**BEFORE THE PUBLIC UTILITY COMMISSION
OF OREGON
UM 1208**

In the Matter of PacifiCorp
Draft 2012 Request for Proposals.

STAFF'S REPLY COMMENTS

Pursuant to Judge Grant's memorandum of September 27, 2006, staff submits its reply comments on PacifiCorp's Draft 2012 Request for Proposals for Base Load Resources (Draft 2012 RFP).

The following chart shows PacifiCorp's *east side* monthly energy position for 2012-2014.

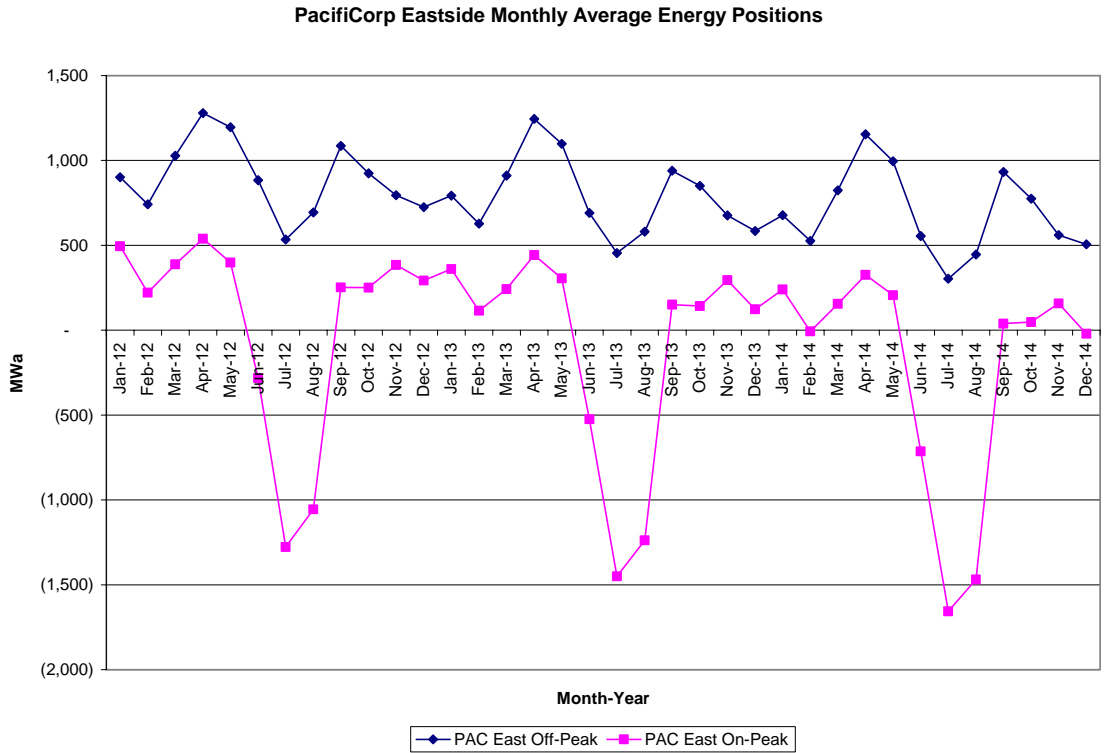
PacifiCorp's energy forecast for the east side of its system shows a long position during all months and delivery periods except during the on-peak hours of June, July and August of 2012-2014.

Meeting the company's resource needs through base load resources¹³ is inappropriate when considering the seasonal nature of its capacity and energy needs on the east side of its system. Short-term market purchases targeting summertime on-peak hours, natural gas-fired peaking resources, and demand response resources are better than 24/7 base load resources at targeting the summertime on-peak shortfall. It appears to staff that PacifiCorp's definition of base load resources prohibits proposals targeting summertime on-peak hours. Considering the company's load-resource balances and load duration curves, staff does not understand why such proposals would not be encouraged.

PacifiCorp System Monthly Average Energy Positions

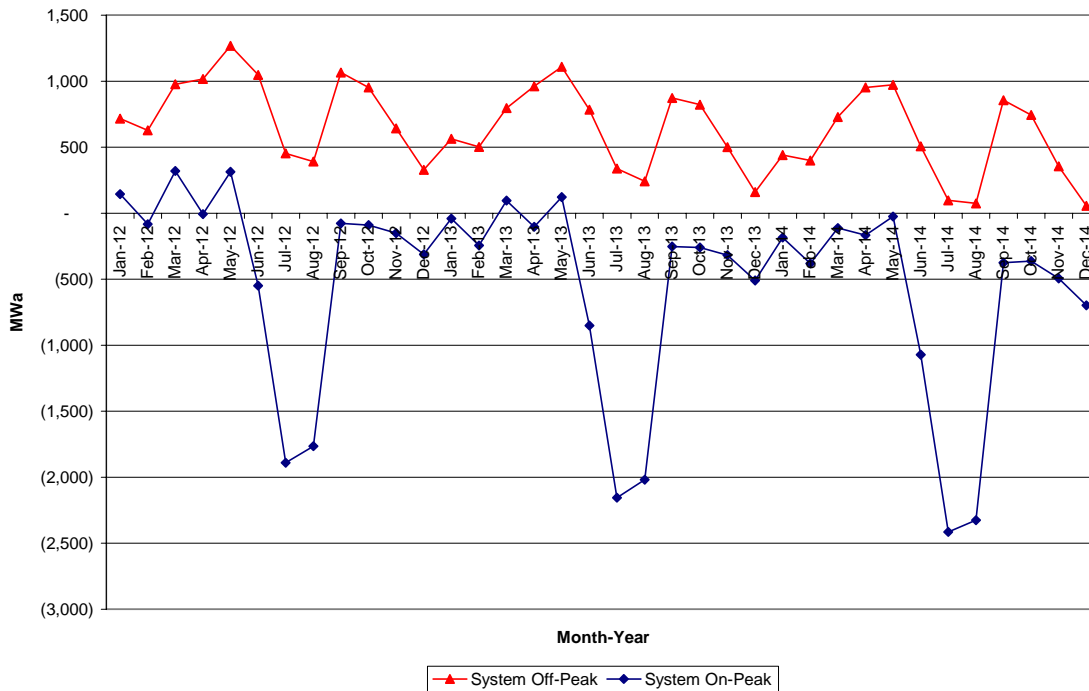
On a total system basis, PacifiCorp forecasts large energy deficits during the on-peak hours of June, July and August of 2012-2014. Small on-peak deficits during non-summer months begin to appear in 2013. The shape of the system energy position is dominated by the summertime energy gap on the east side of the system.

Figure 11b – East-Side Coincident Peak Capacity Chart

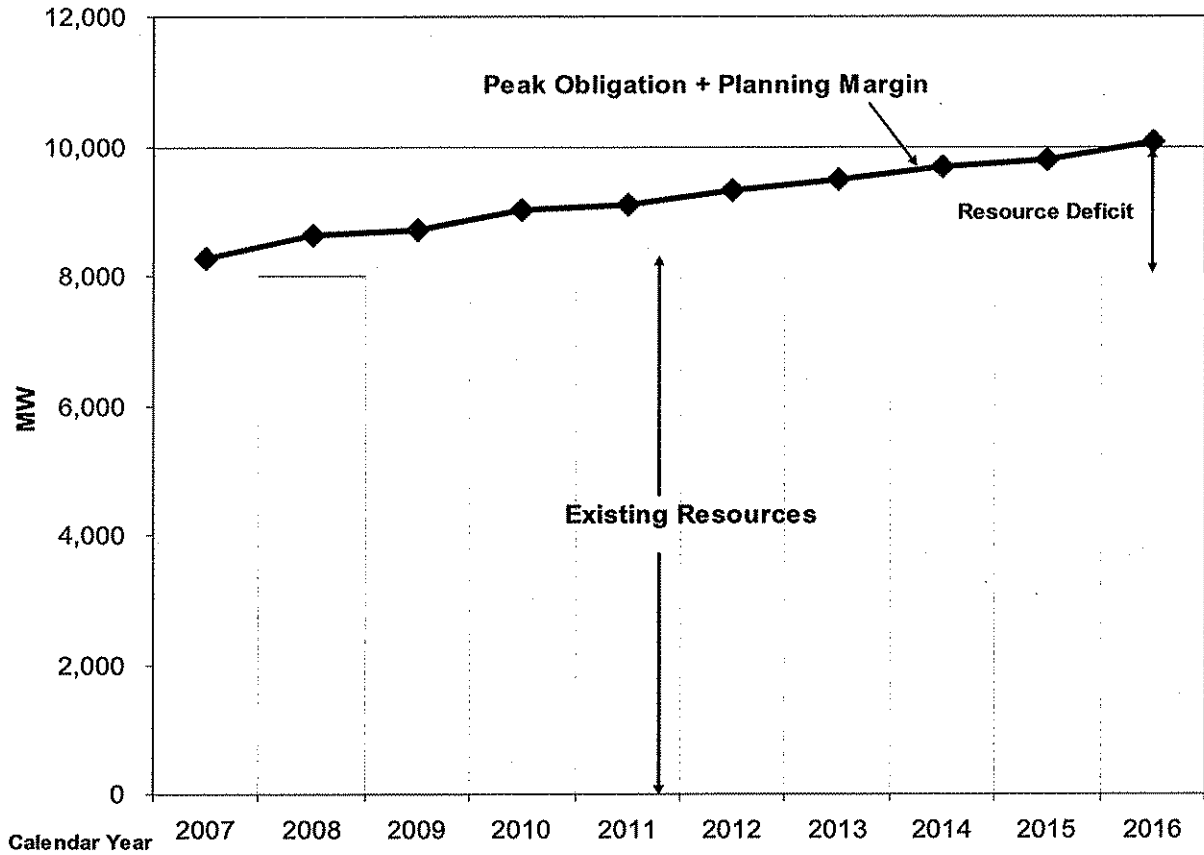
Staff finding: PacifiCorp's summertime capacity gap on the east side of its system under the company's assumed planning margin is 1,268 MW in 2012 and grows to 1,639 MW in 2014. Because these gaps are based on a 15 percent planning reserve margin and the single peak hour of the year, staff considers these numbers to be an upper bound on total capacity acquisition targets. As described above, the Commission did not acknowledge the company's 15 percent planning reserve margin. PacifiCorp's 2006 IRP analysis may show that a lower planning margin, such as 12 percent, is appropriate.
